Council's previous submissions on this development raised concerns regarding the long term impacts of the carparking solutions for this development. In particular the provision of above-ground parking, surface and multi-storey, to the north of the site on prime potential recreation grounds that are adjoining and upland of bushland and riparian areas, and visible from the residential areas across the valley.

3) A minor alteration to the approved location and internal flow of the multi-deck carpark (bringing the structure closer to the hospital wings and allowing pedestrian access at the one level); and

**PLEASE REFER TO ATTACHMENTS 1,2,3,4,5 – mark ups of drawings**

**Table 1 – Alterations to Levels of the Modified Multi-Deck carpark**

LEVEL 2

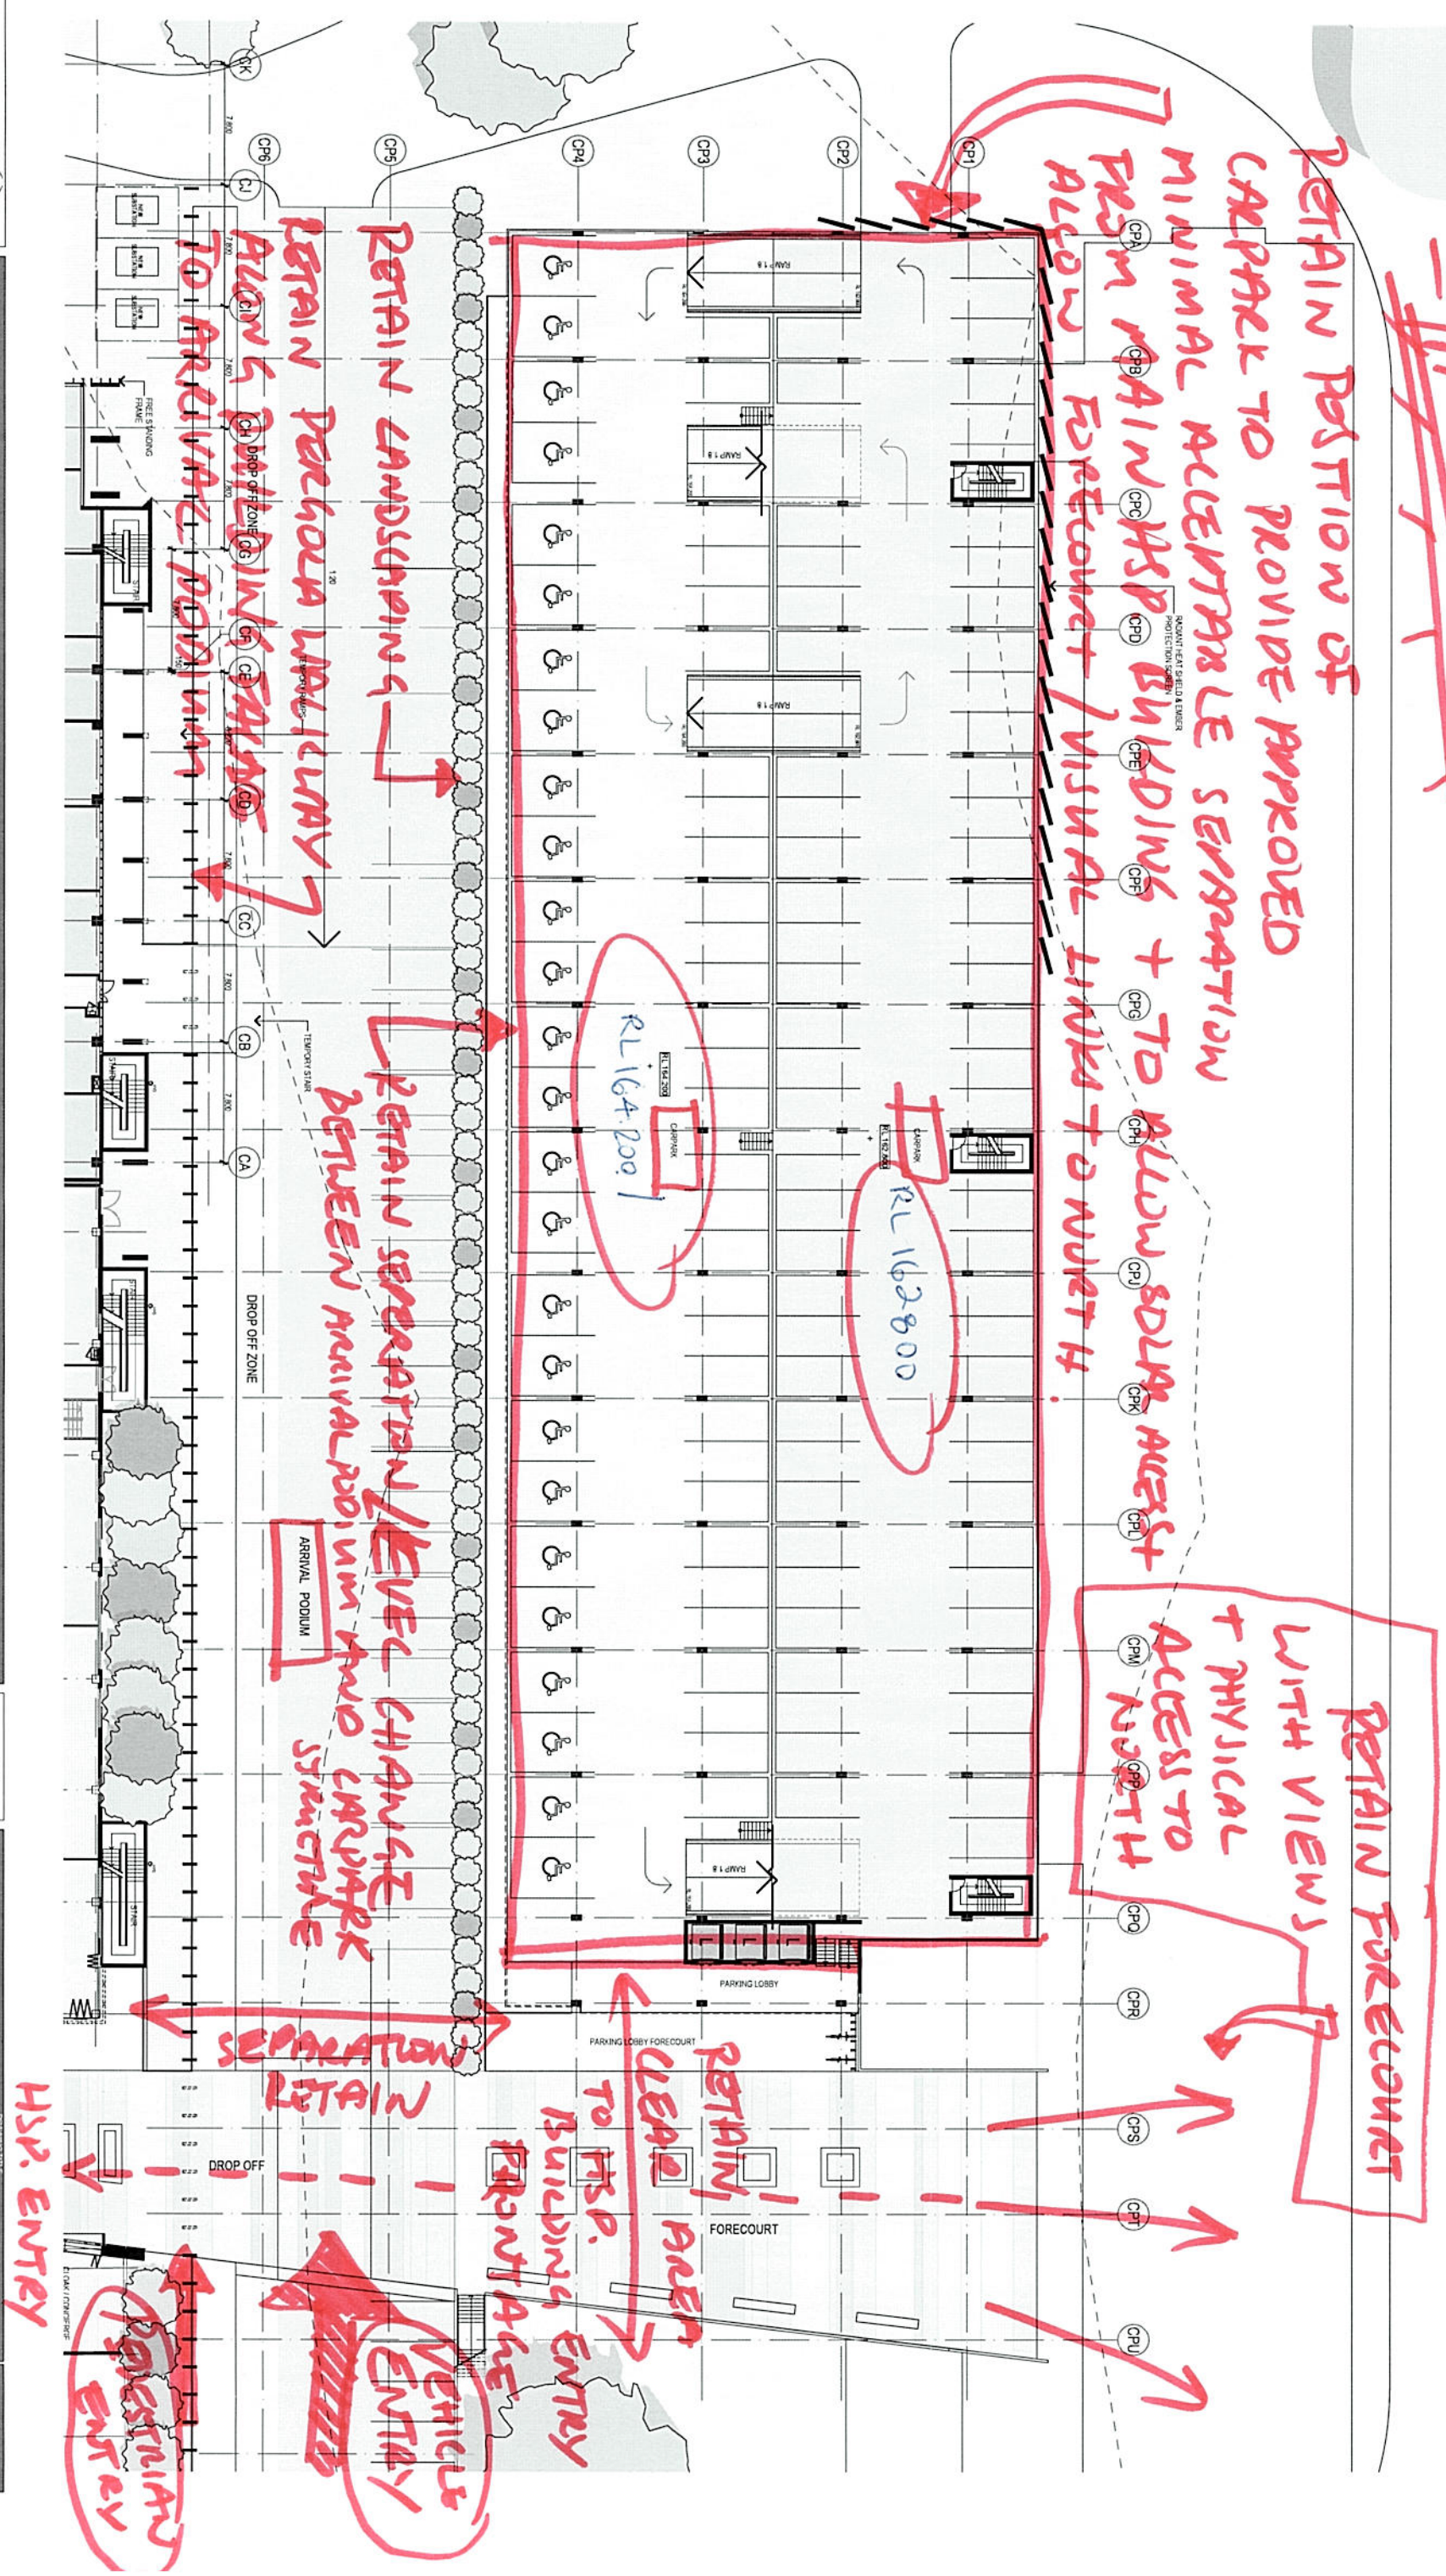
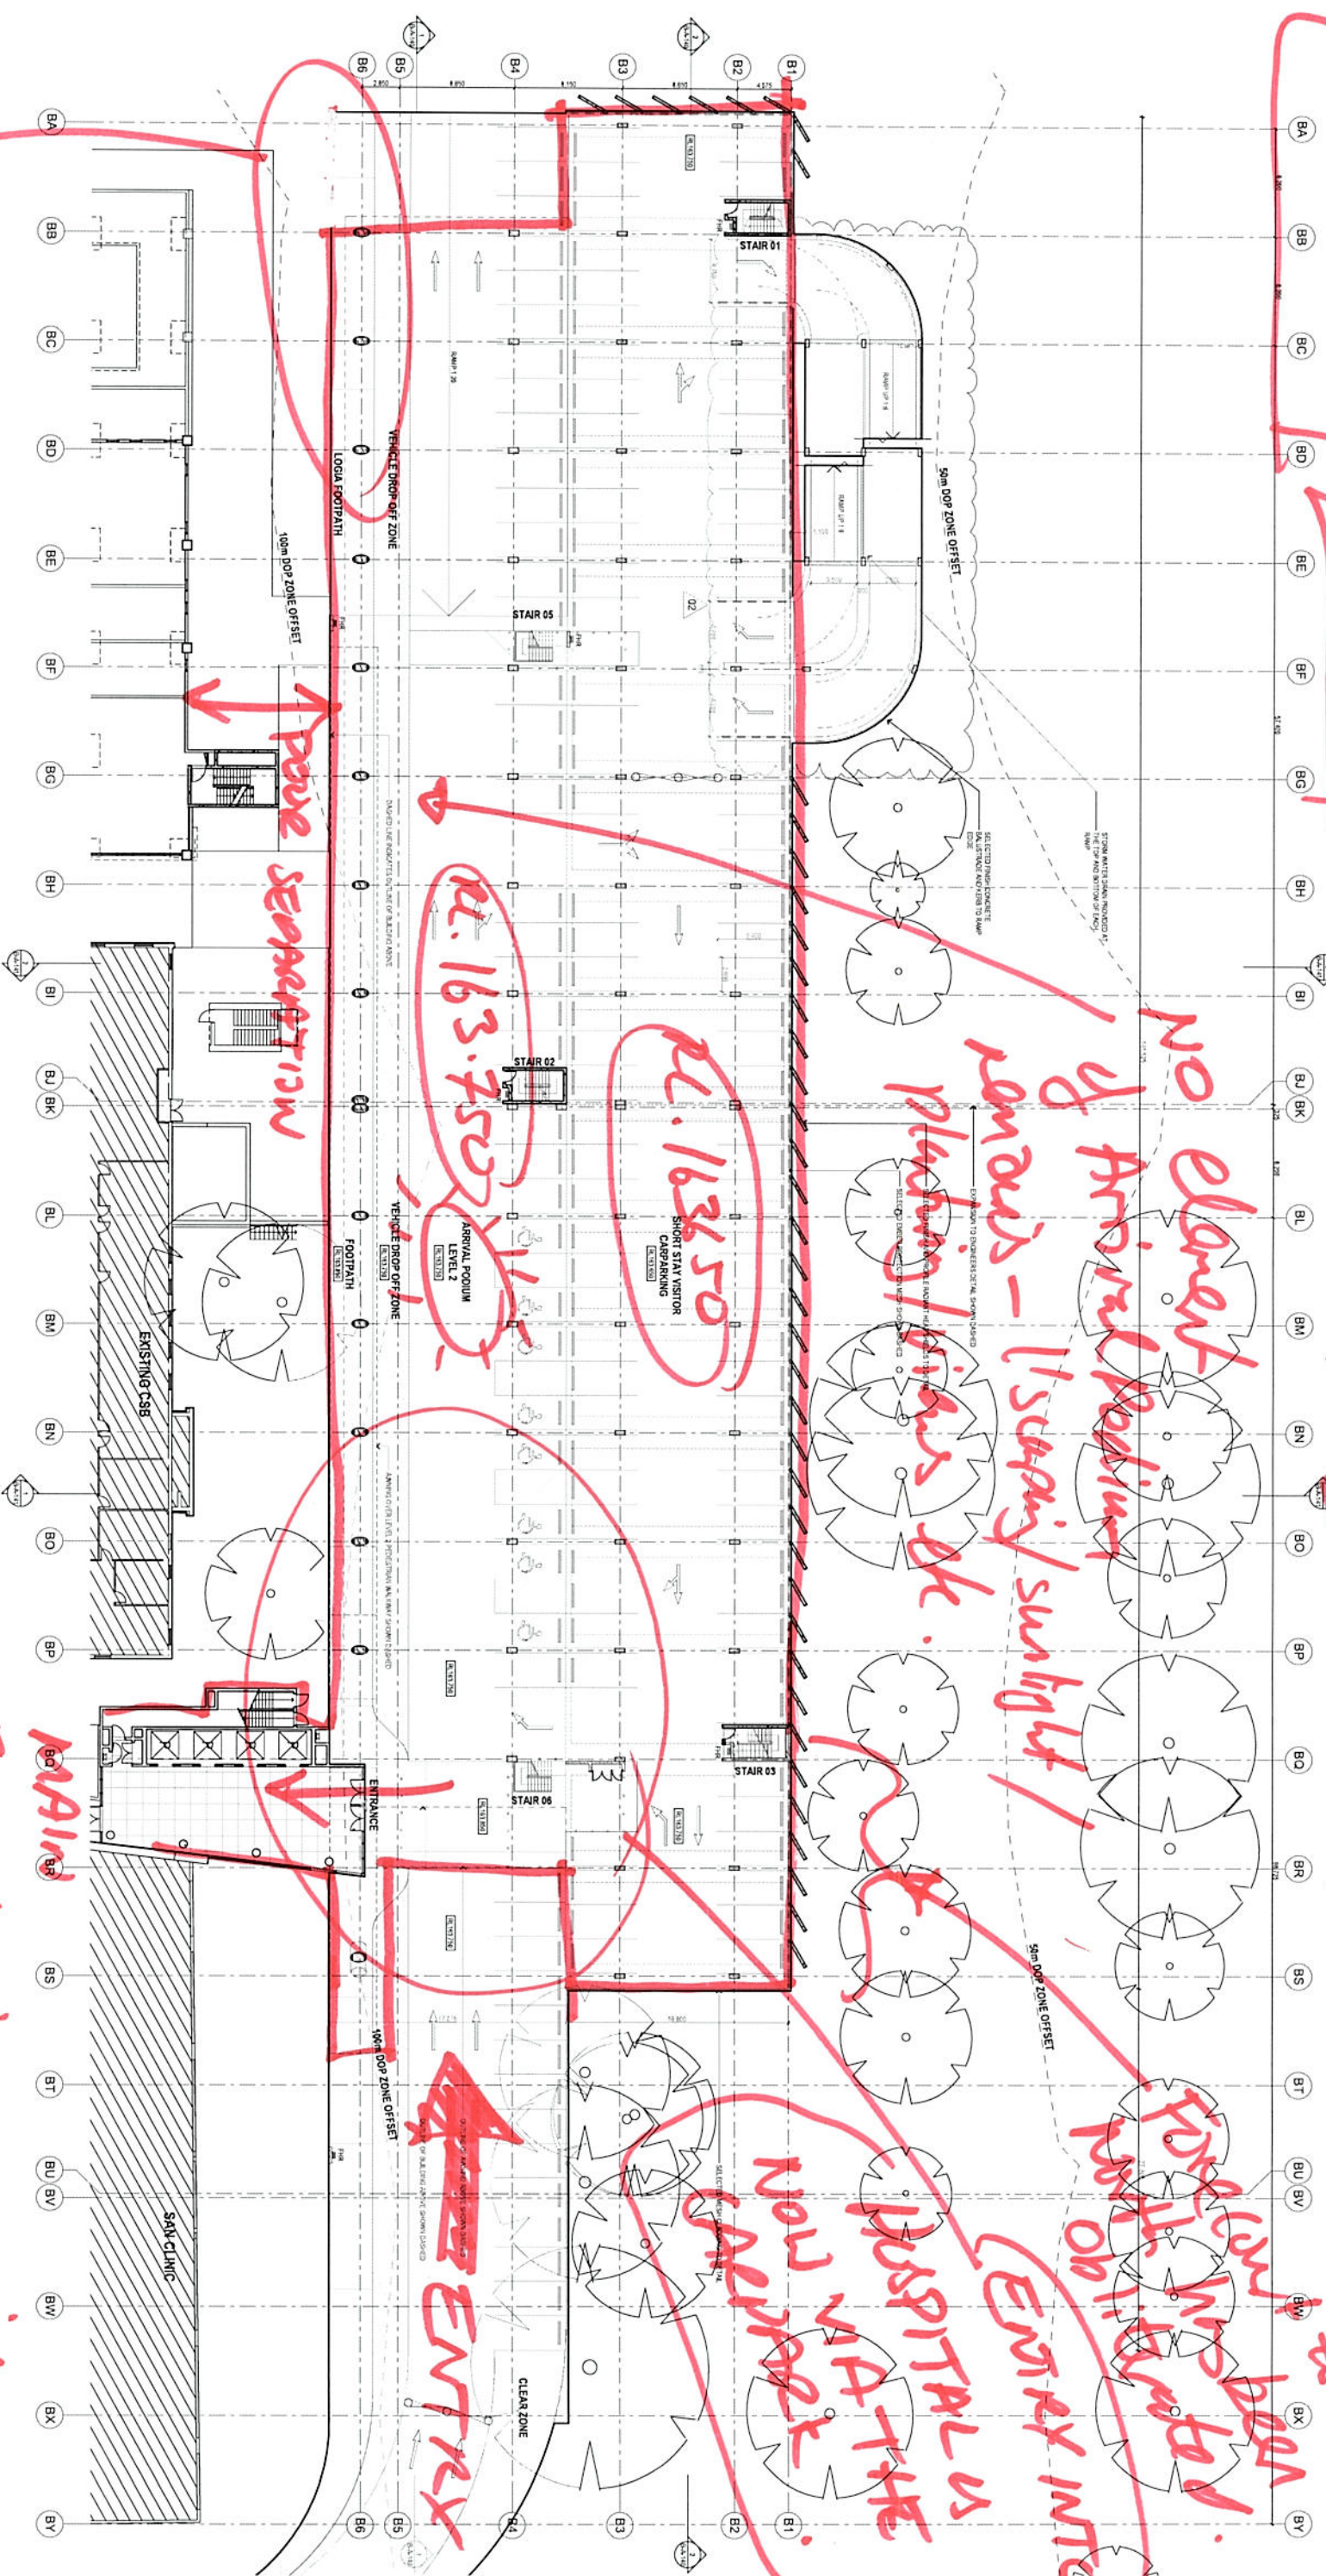
Walking / pergoes to hospital but they have been removed.

Entry - is now joined to Carpal experience.
